ISC-C1 Rack

Title ISC System Wiring Diagram		
Size B	Number D1900511	Revision V7
Date: 8/24/2022	Sheet of 1	38
File: C:\Users\...ISC_C1_SH1.SchDoc	Drawn By: Filiberto Clara

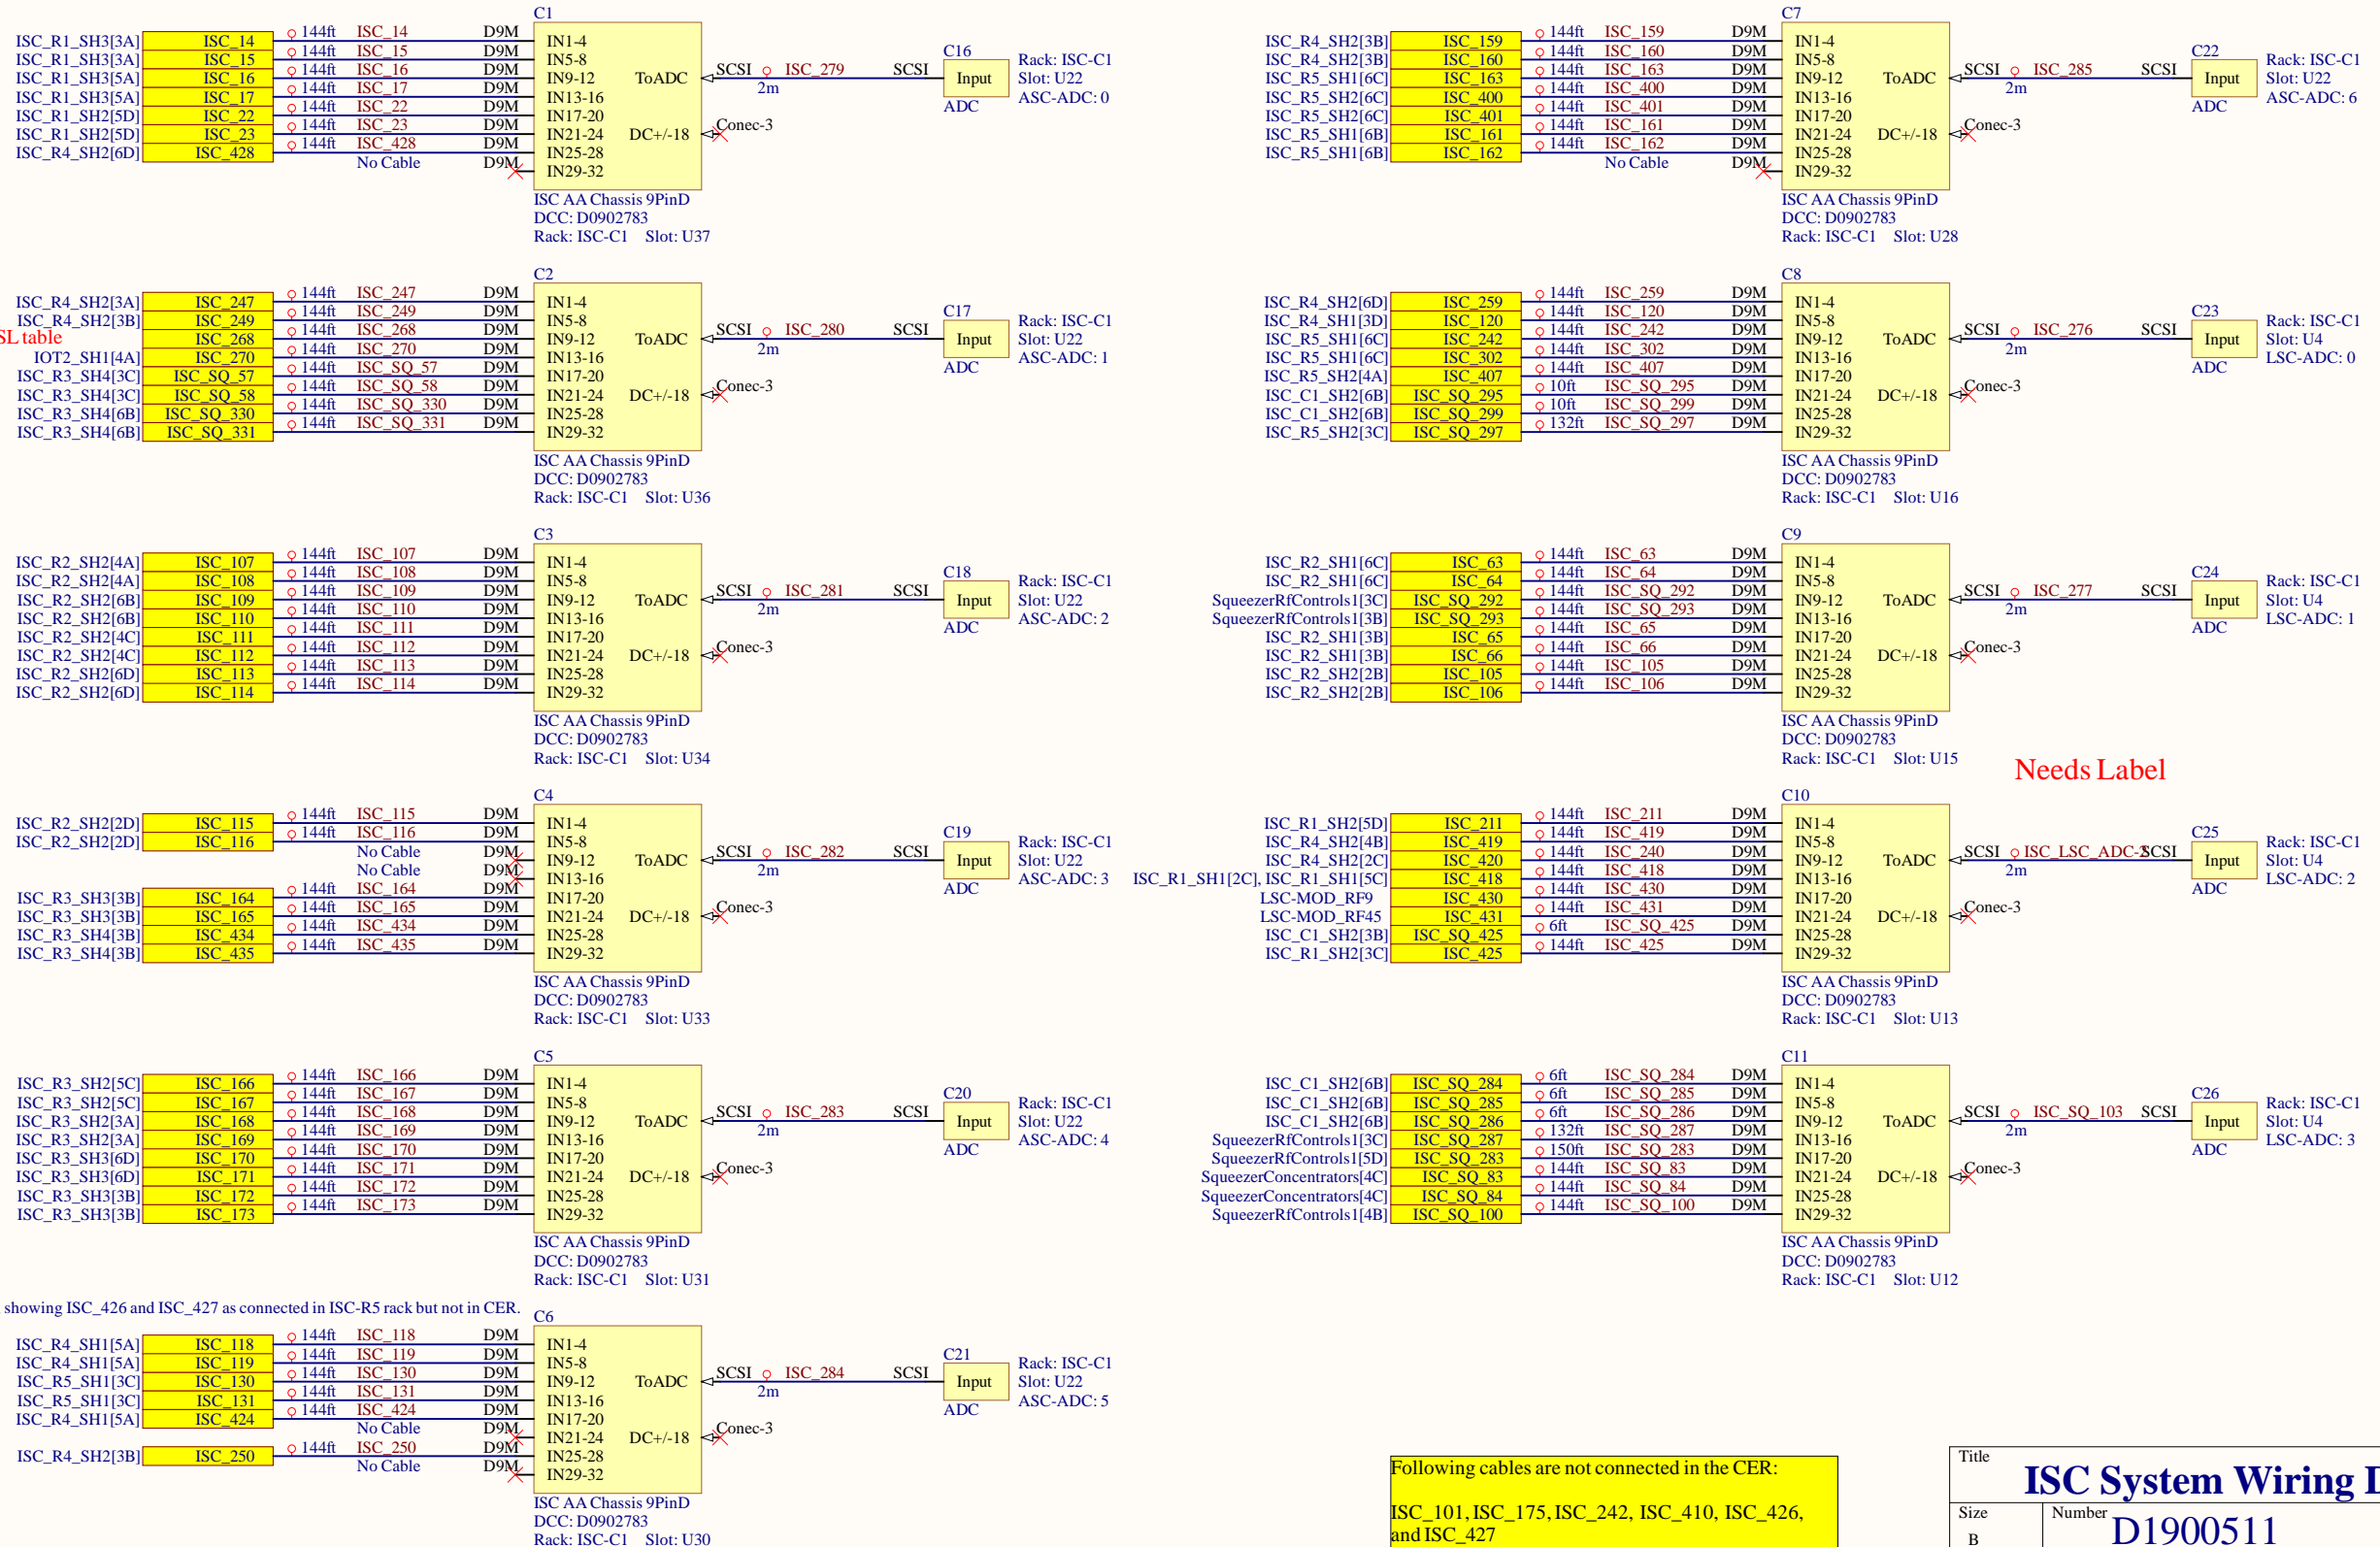
Reverify cables, showing ISC_426 and ISC_427 as connected in ISC-R5 rack but not in CER.

Following cables are not connected in the CER:
ISC_101, ISC_175, ISC_242, ISC_410, ISC_426,
and ISC_427

ISC-C3 Rack

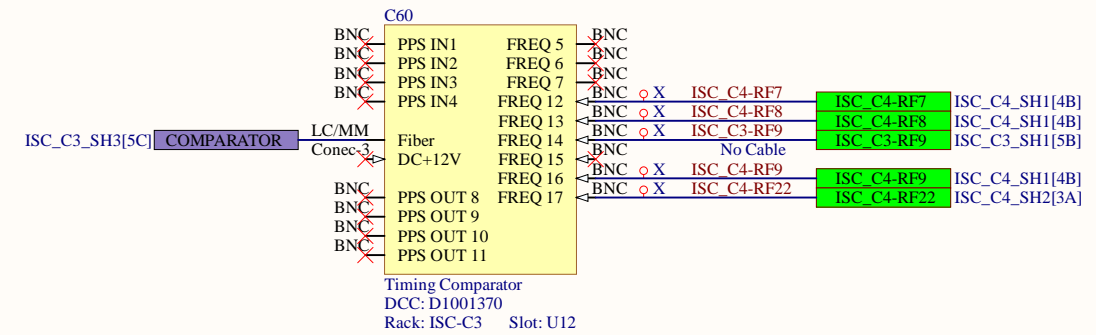
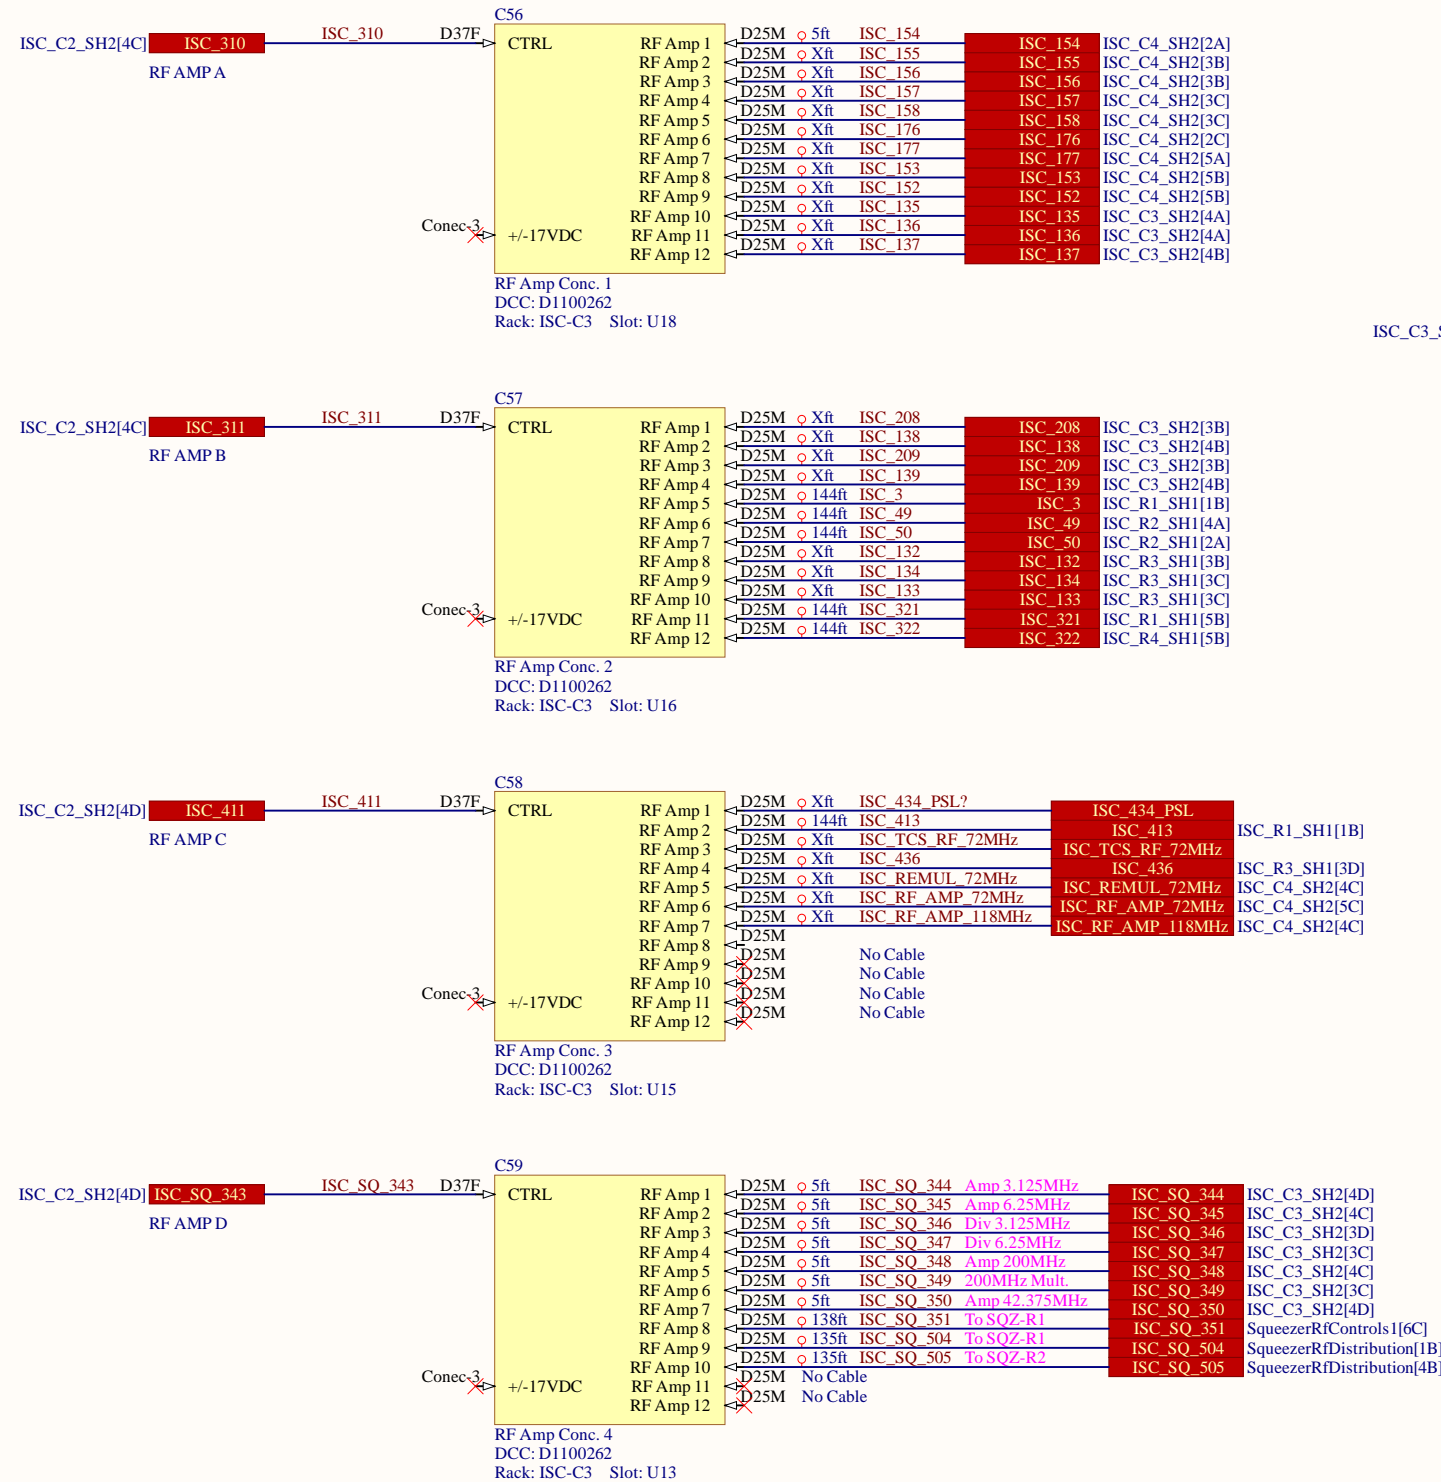
Need to label IFR cable with RF22

ISC-C3 Rack

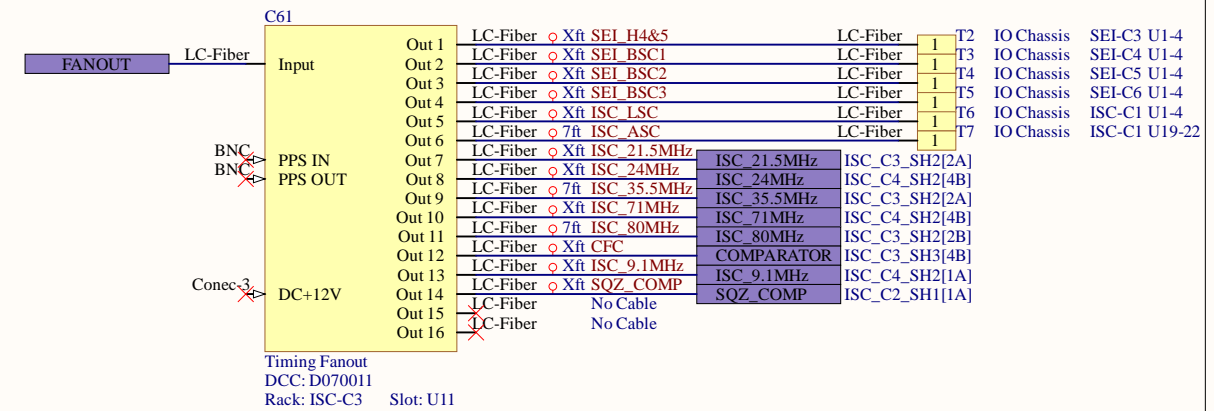
Need Locations of other ends.
 SEI IO Chassis

ISC-C4 Rack

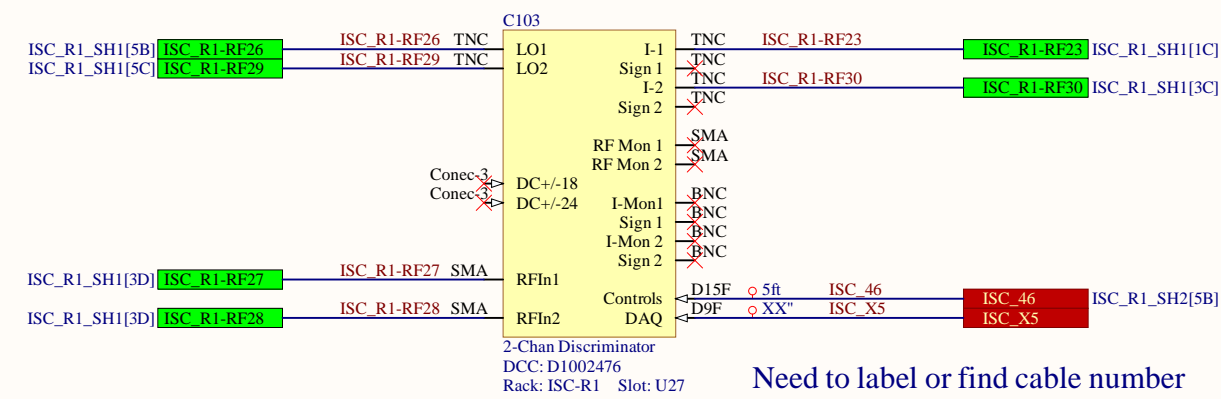
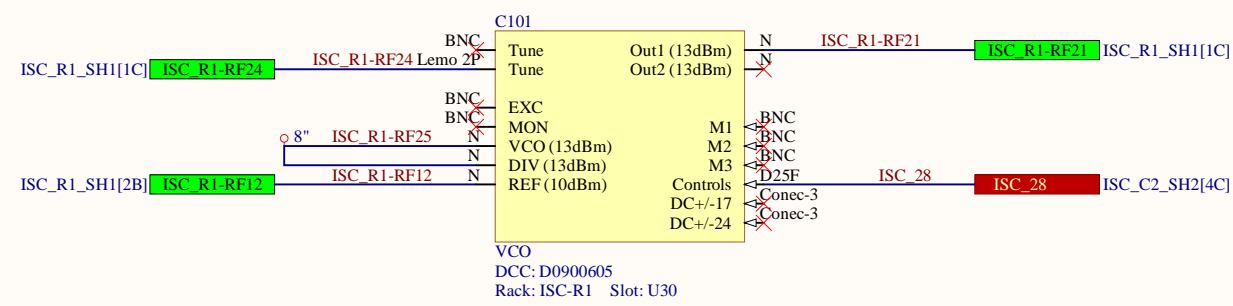
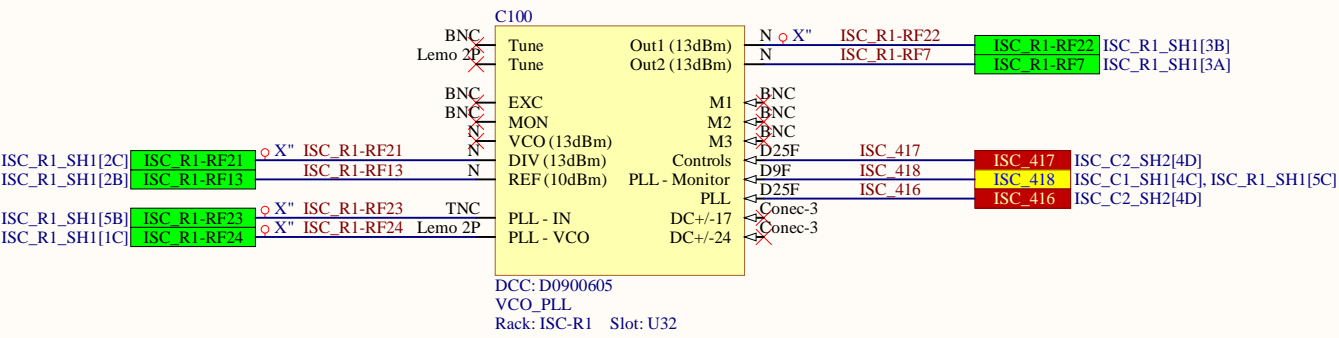
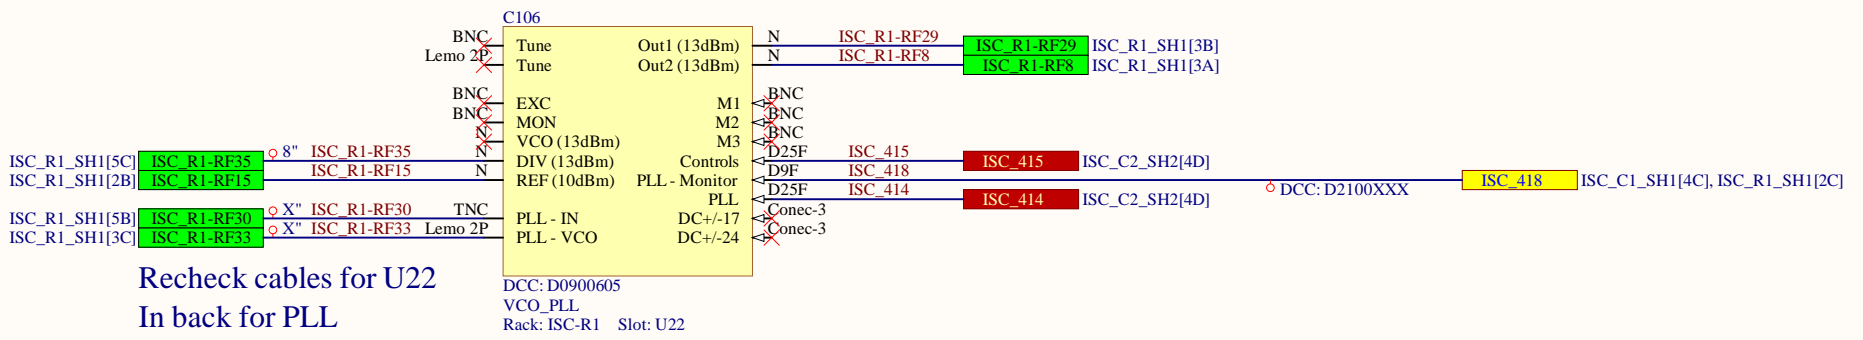
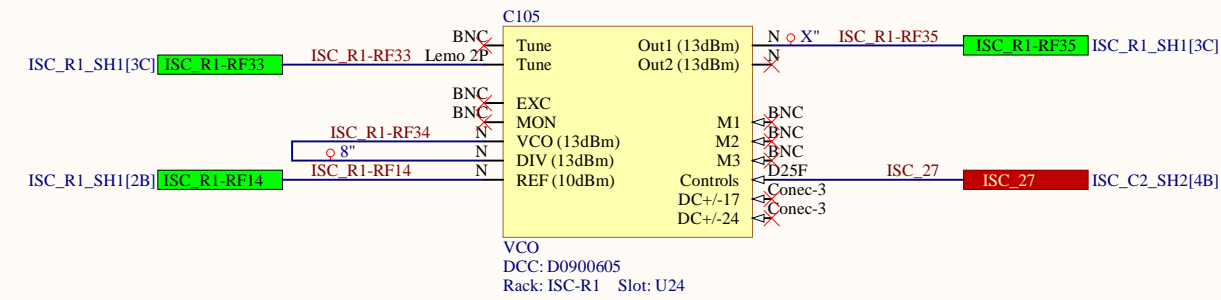
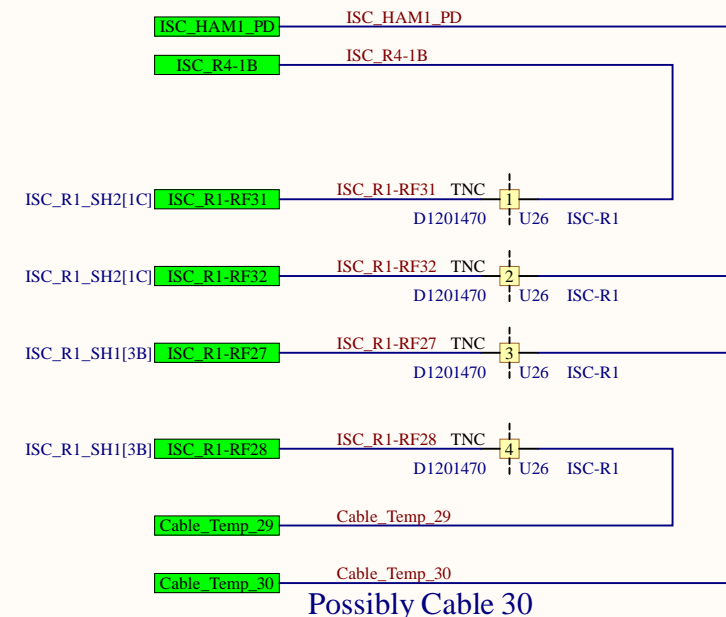
Need to label or find cable number

Recheck cables for U22
In back for PLL

ISC-R1 Rack

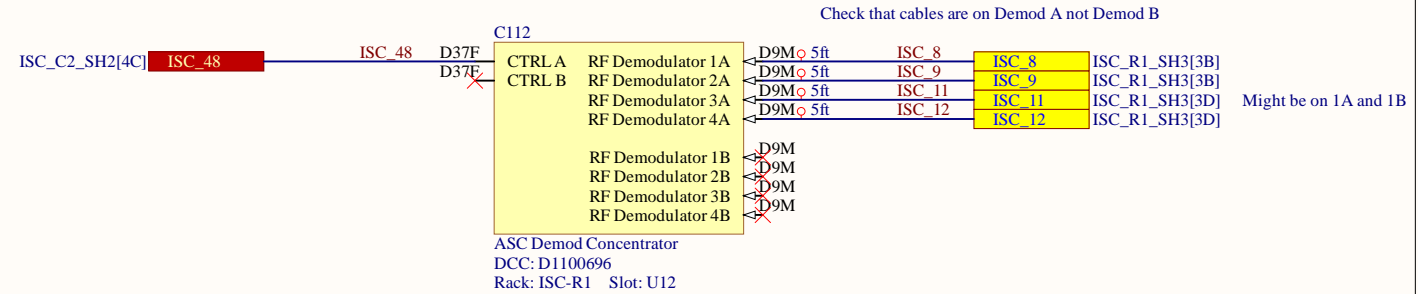
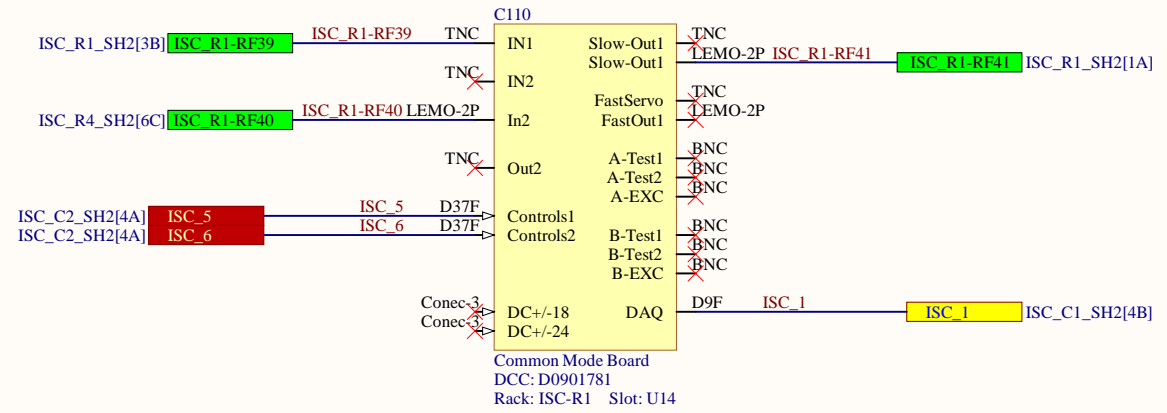
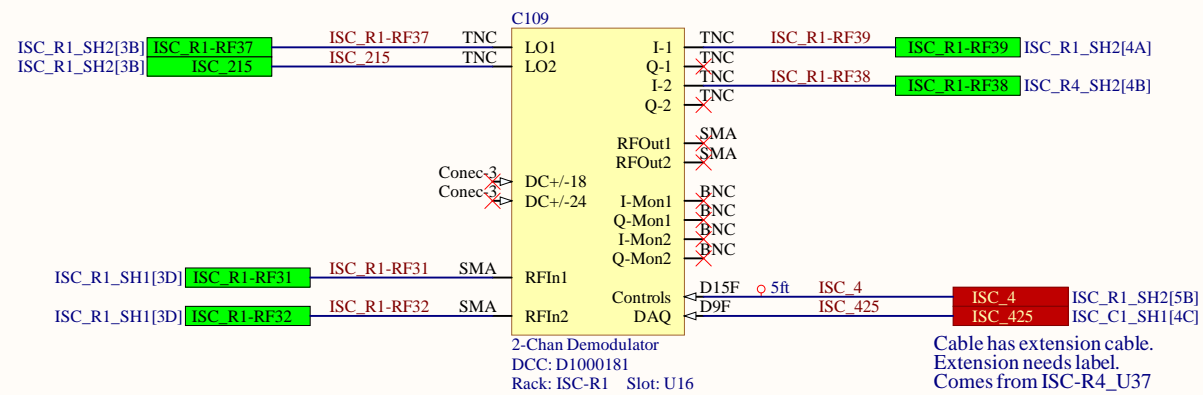
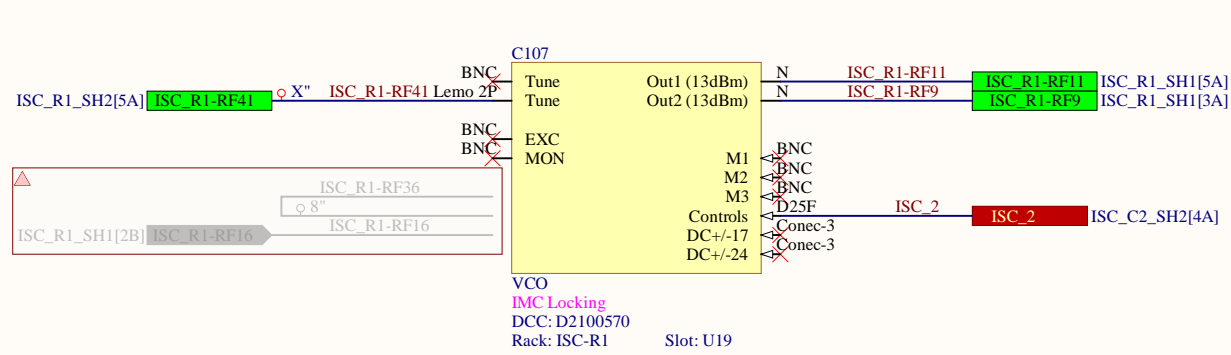
Need to Locate other end
